# Access Compliance Report

## Public Rights-of-Way

### (Curb Ramps)

Intersection ID: 48571	Main Street: DAPPLE_CT	Cross Street: SALAMANDER_RUN_LN	Location:	E
ADA ID: F7FA83617432	Ramp Type: PerpDiag	Initial Pass/Fail: Fail	Overall Compliance: No	Severity Score: 10
Codes/Mitigation Info/Possible Solution		Field Measurements/Component Compliance

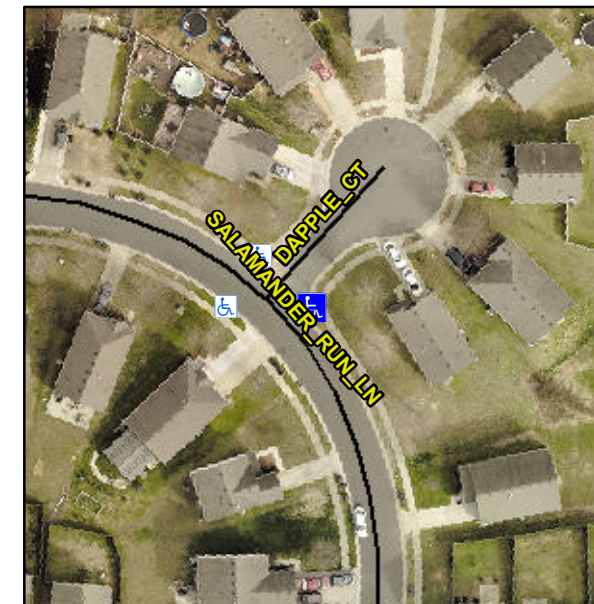
**Not Found, R304.5.1, R304.5.3**

Compliance	Description	Data	Compliance	Description	Data
N/A	Ramp Length (in)	47.0	Yes	Ramp Slope (%)	6.6
No	Ramp Width (in)	47.5	No	Ramp XSlope (%)	3.0
N/A	Flare Type LT	N/A	N/A	Flare Type RT	N/A
N/A	Flare Slope LT (%)	N/A	N/A	Flare Slope RT (%)	N/A
N/A	Flare Traversable LT?	N/A	N/A	Flare Traversable RT?	N/A
N/A	Landing Length (in)	N/A	N/A	DWS Provided?	N/A
N/A	Landing Width (in)	N/A	N/A	DWS Contrast?	N/A
N/A	Landing Slope (%)	N/A	N/A	DWS Length (in)	N/A
N/A	Landing X Slope (%)	N/A	N/A	DWS Full Width?	N/A
N/A	Landing Curb? (Y/N)	N/A	N/A	DWS Offset (in)	N/A
N/A	Shared Landing?	N/A			
N/A	Gutter Ponding?	Yes	N/A	Gutter Slope (%)	N/A
N/A	Gutter Lip Ht (in)	0.75	N/A	Gutter X Slope (%)	N/A
N/A	Painted X Walk1?	No	N/A	Painted X Walk2?	No
	X Walk 1 Direction	To NW		X Walk 2 Direction	To SW
N/A	X Walk 1 Width (in)	N/A	N/A	X Walk 2 Width (in)	N/A
	X Walk 1 Slope (%)	1.5		X Walk 2 Slope (%)	2.9
	X Walk 1 X Slope (%)	0.7		X Walk 2 X Slope (%)	1.9

**Remove & Replace Curb Ramp With Two New Directional Ramps or Equivalent.**
